MKM
architecture + design

Project 25009 – Daniel’s Place Respite Care
New Construction: 639 North Market St., North Manchester, Indiana, 46926

ADDENDUM No. 2

December 09, 2025

6 CASEWORK DTL.
1" = 1'-0"

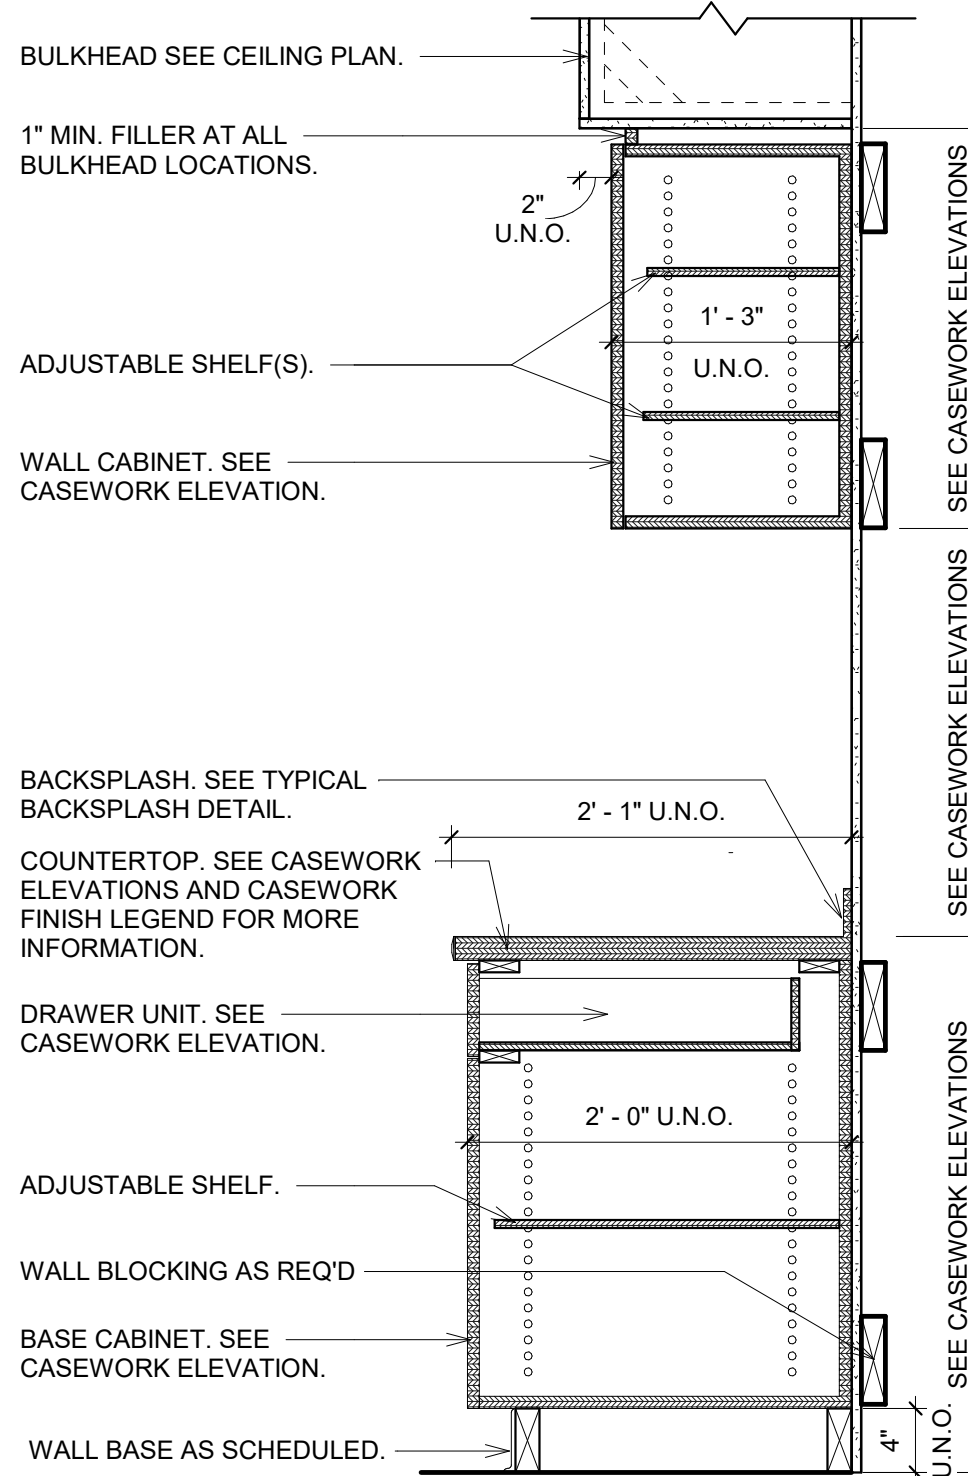
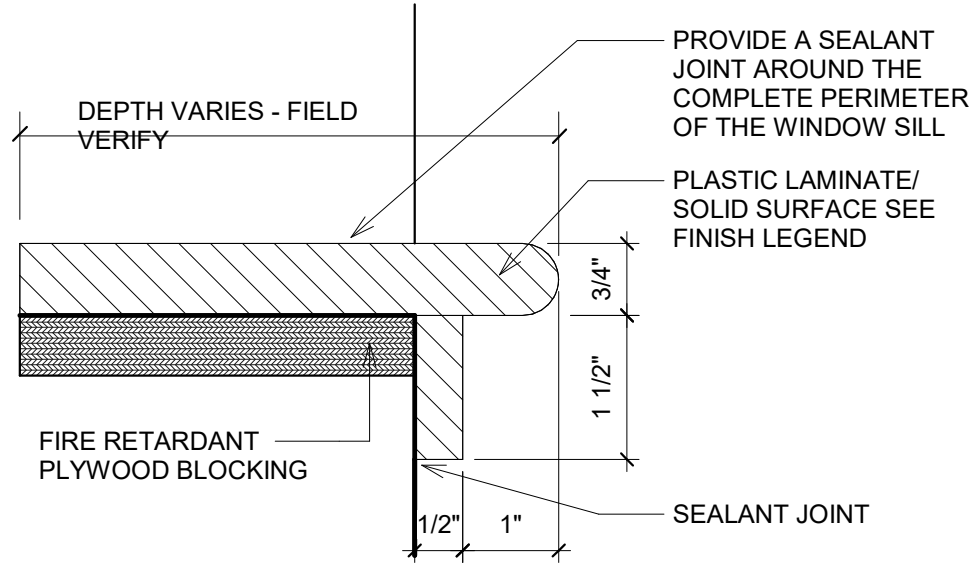
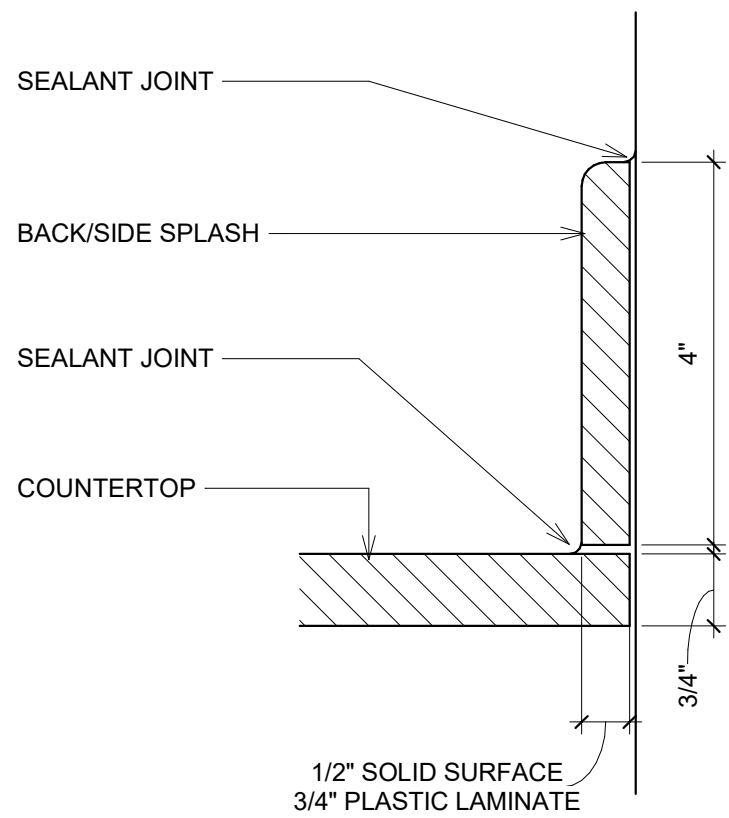
- 9. Sheet A-410 – Casework General Notes, Legend & Details.**
 - a. Clarification: See attached revised sheet for revisions to detail #3.
- 10. Sheet A-611 – Window Elevations & Details**

DRAWING CONTENTS:
SITE ELECTRICAL PLAN

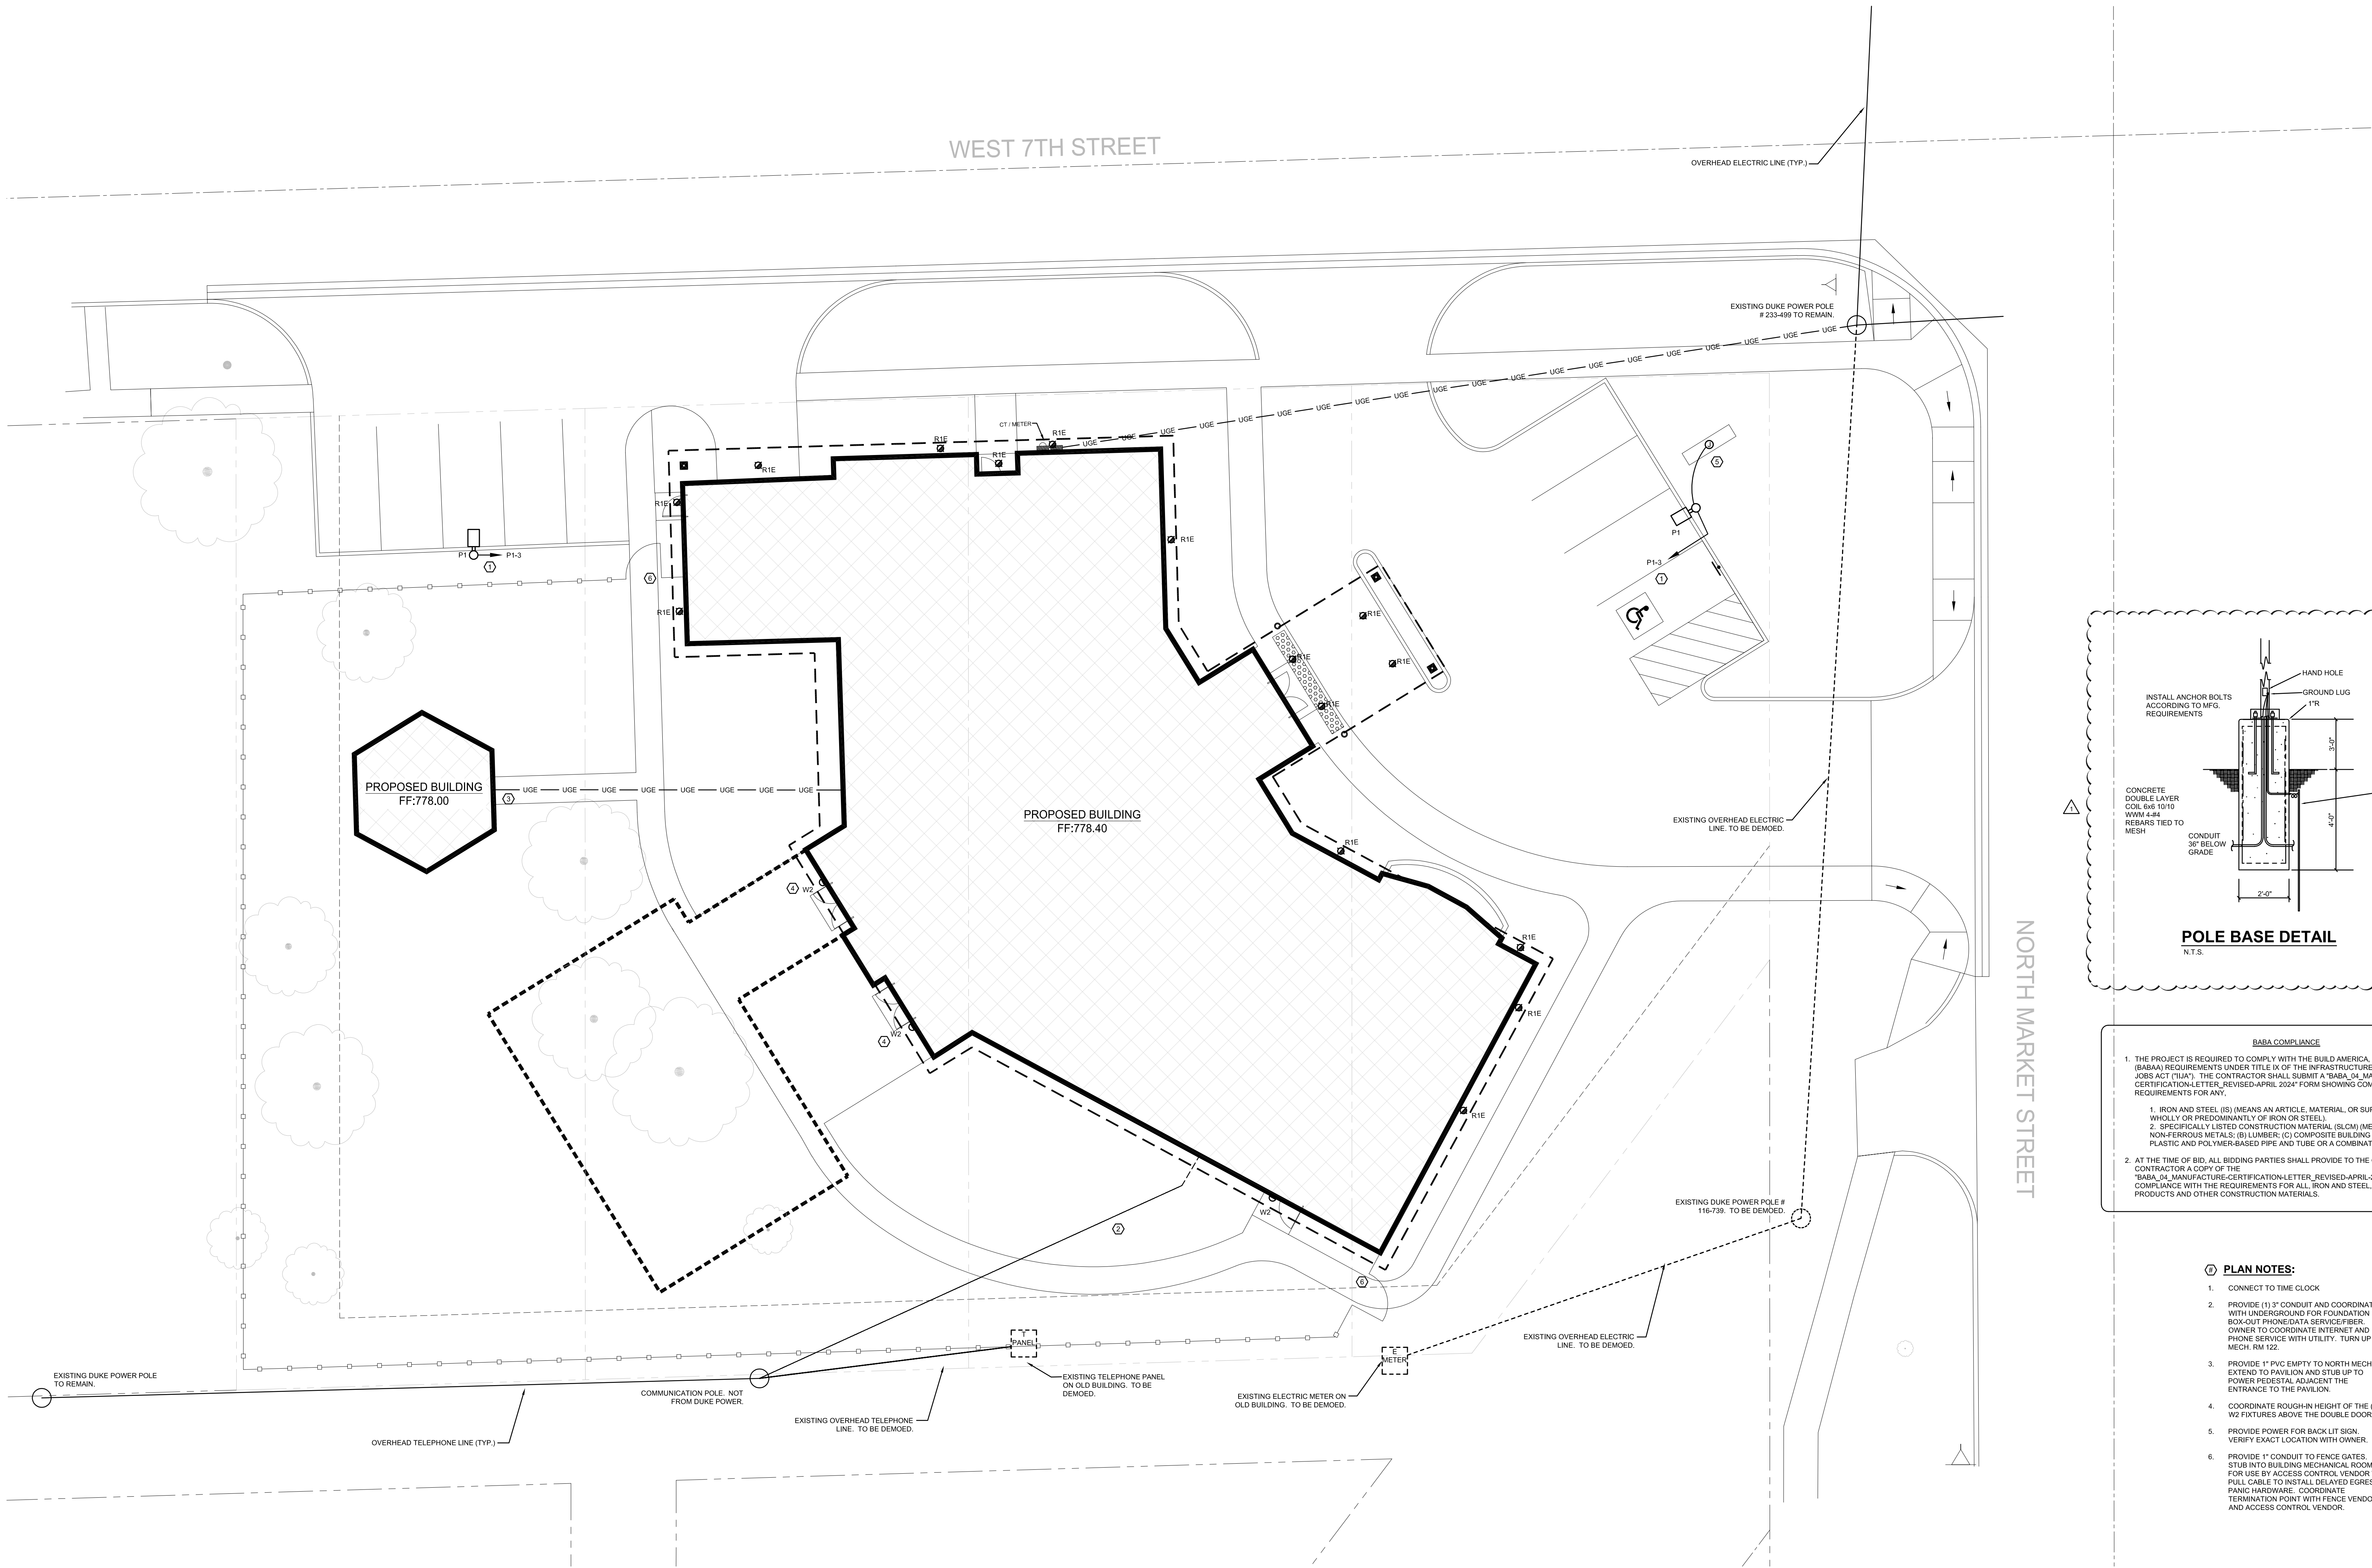
- 12. Sheet E-100 – Site Electrical Plan**
 - a. Clarification: See attached revised sheet for addition of light pole base detail.
- 13. Sheet E-101 – First Floor Lighting Plan**

E-101

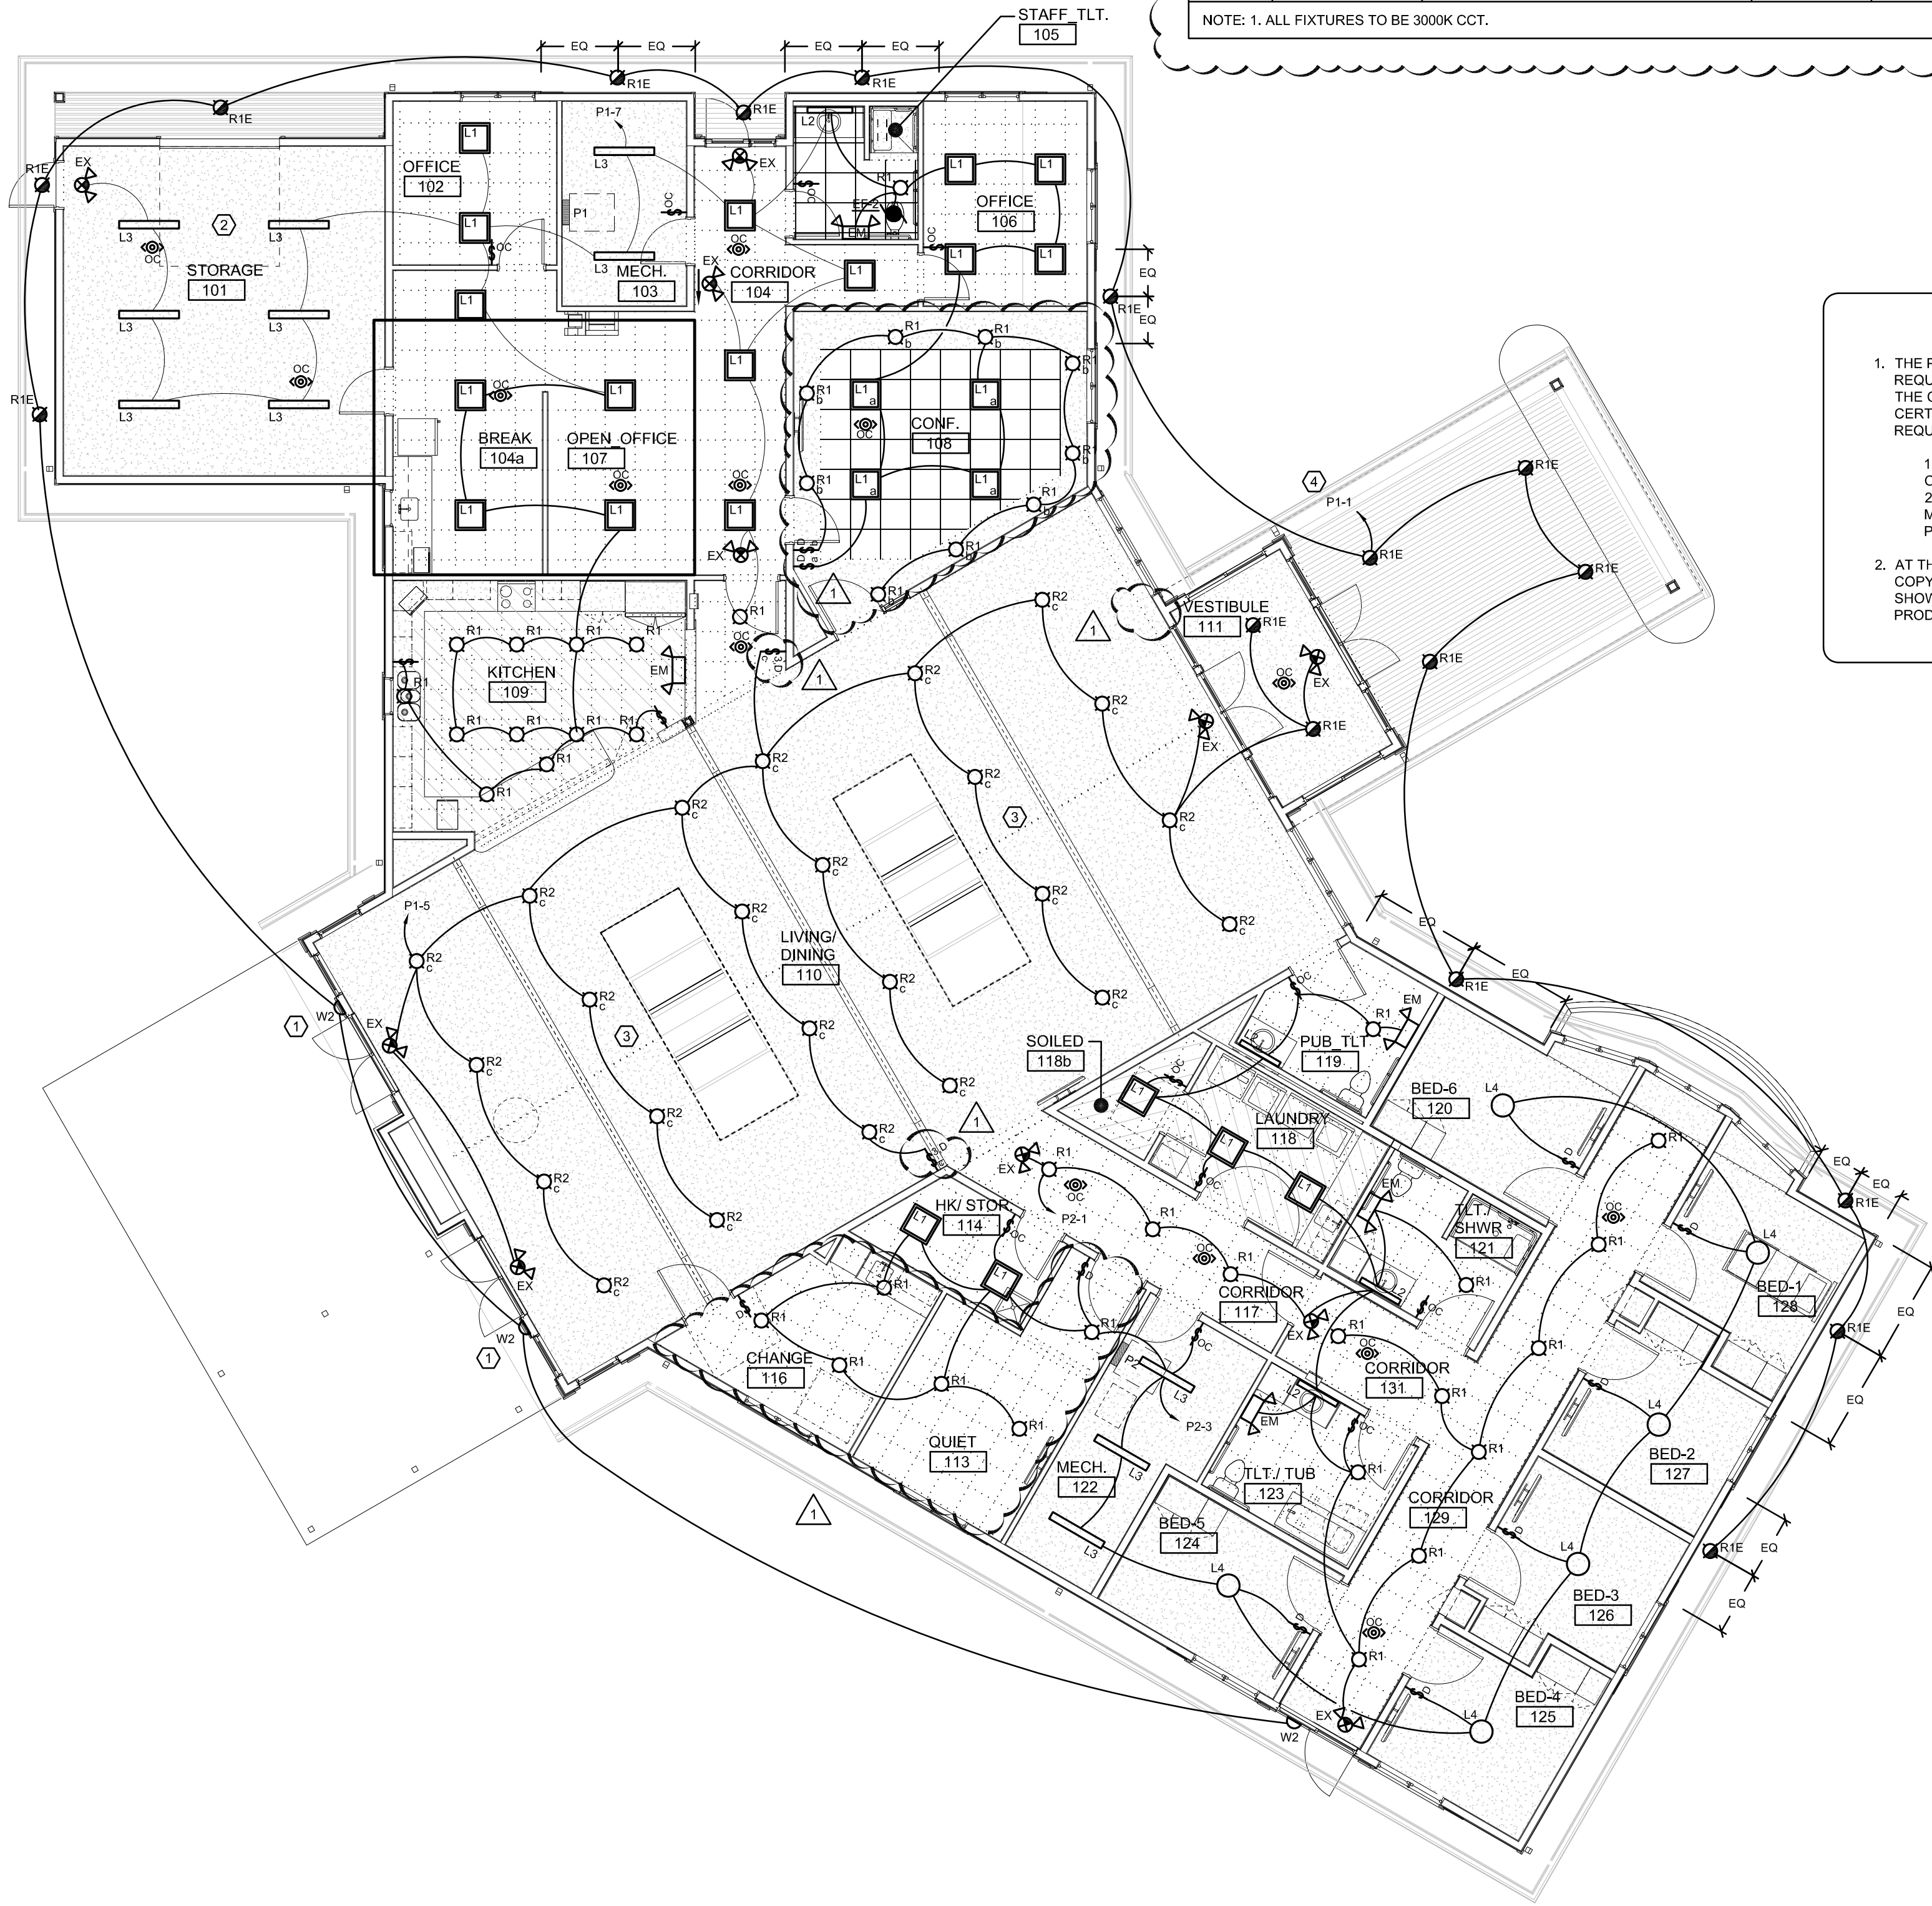
- a. Clarification: See attached revised sheet for revision to lighting locations and switches in rooms 109, 110, 113, 116
 - b. Clarification: See attached revised sheet with clarification to fixture schedule.
